RECREATIONAL VEHICLE
SAFETY RECALL NOTICE

Safety Recall: 23V-822

IMPORTANT SAFETY RECALL – 4th Notice

Figure 1

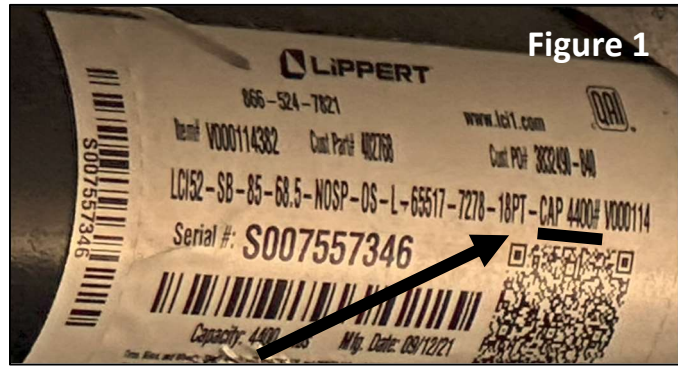
It has been decided that the vehicles in the recall population may have axle springs rated at 4400 pounds rather than the 5100 pound axle rating as specified on Federal Identification Tag. The axles installed had the wrong size springs. Under certain conditions during travel, undersized axle springs can be overloaded leading to an increased risk of axle spring failure and increasing the risk of a crash.

You may choose to self-inspect the axle's tags. If the tag reads as CAP 4400#, as shown in Figure 1, as soon as possible, please make an appointment to have your RV serviced by your dealership. Customers should unload all cargo and empty holding tanks (fresh water, grey water, black water, and water heater) and take their unit to an authorized dealer for remedy of the incorrectly installed axles springs. The labor

Keystone representatives have been in contact with the staff at your selling dealership regarding this situation. The remedy is to replace under rated 4400 LB springs with the correct size 5100 LB springs. This would require both 2200 LB springs be replaced. The service and parts required for this corrective action will be provided at no charge to you.
